MIL-F-63229 (AR)
AMENDMENT 1
8 SEPTEMBER 1983
SUPERSEDING
MIL-F-63229 (AR)
17 August 1979

MILITARY SPECIFICATION

FUZE, PIBD, XM740, SHOCK WAVE SENSOR FOR

This amendment forms a part of Military Specification MIL-F-63229 (AR) dated 17 August 1979, and is approved for use by the U.S. Army Armament, Munitions and Chemical Command and is available for use by all Departments and Agencies of the Department of Defense.

FIGURE 1 - Direction of Applied Acceleration

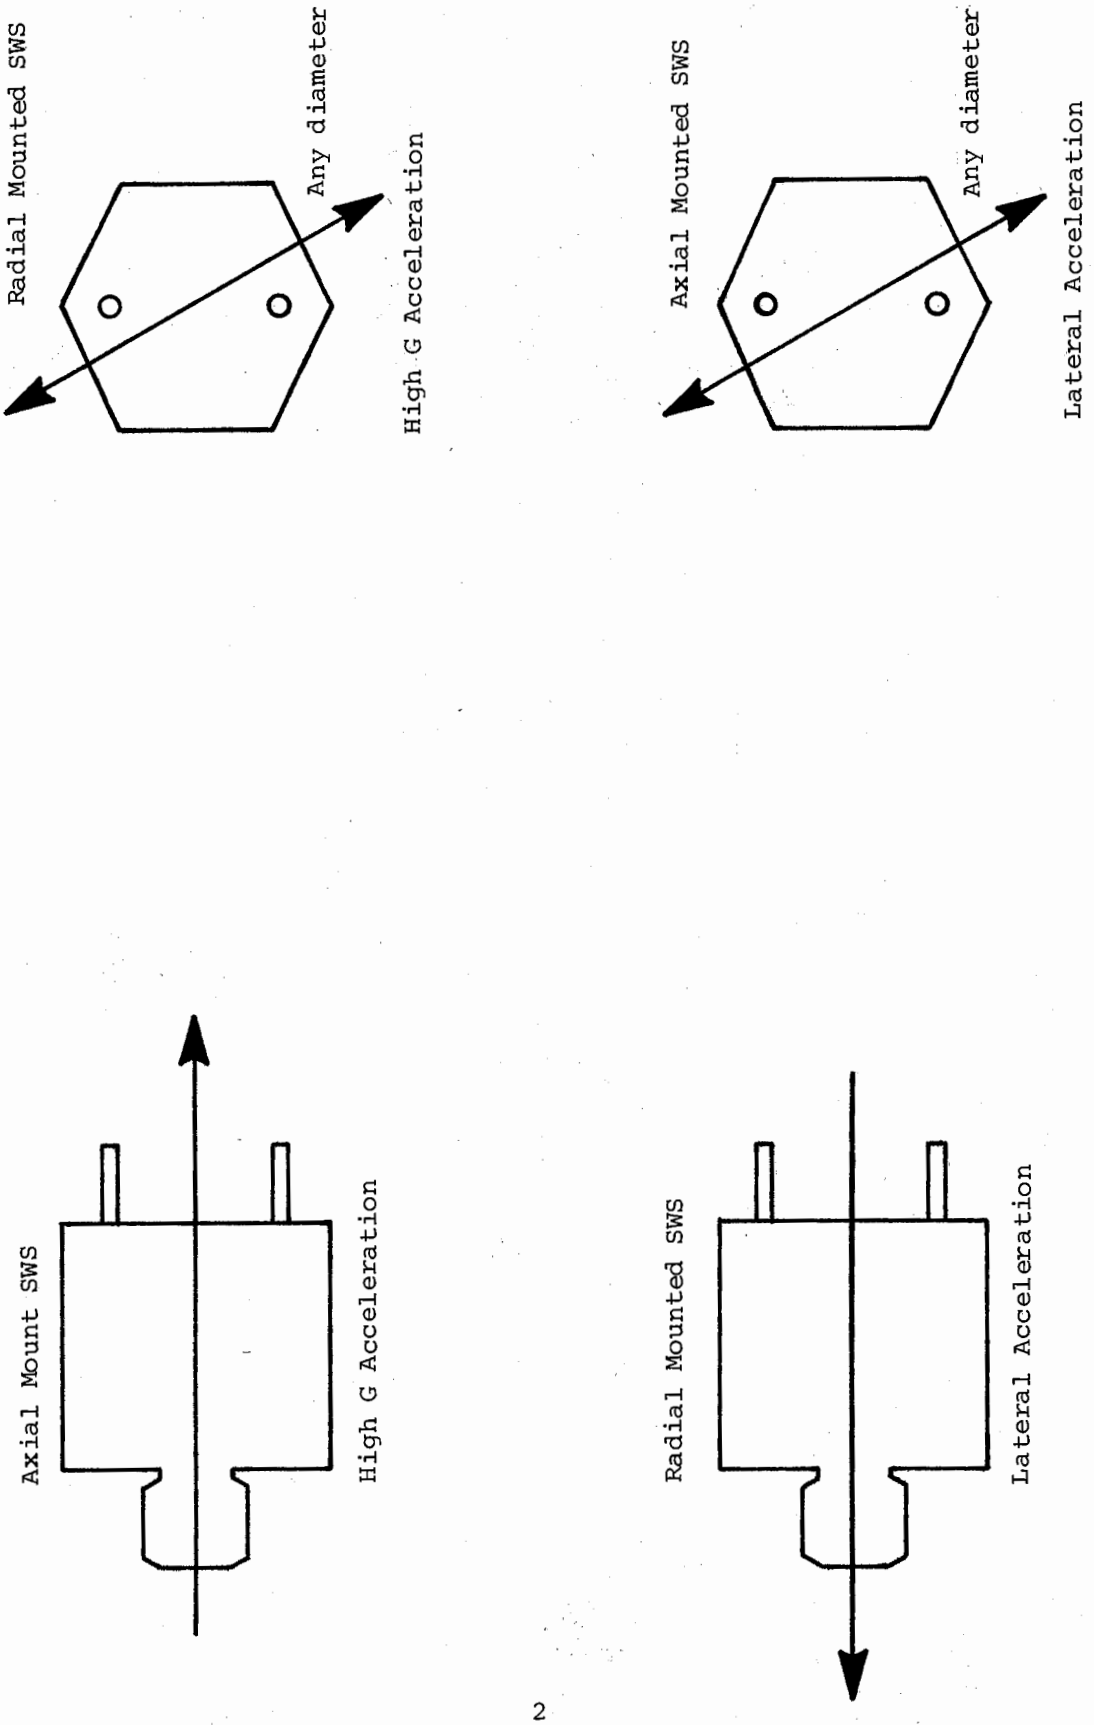
Figure 1: Delete in its entirety and substitute the following:
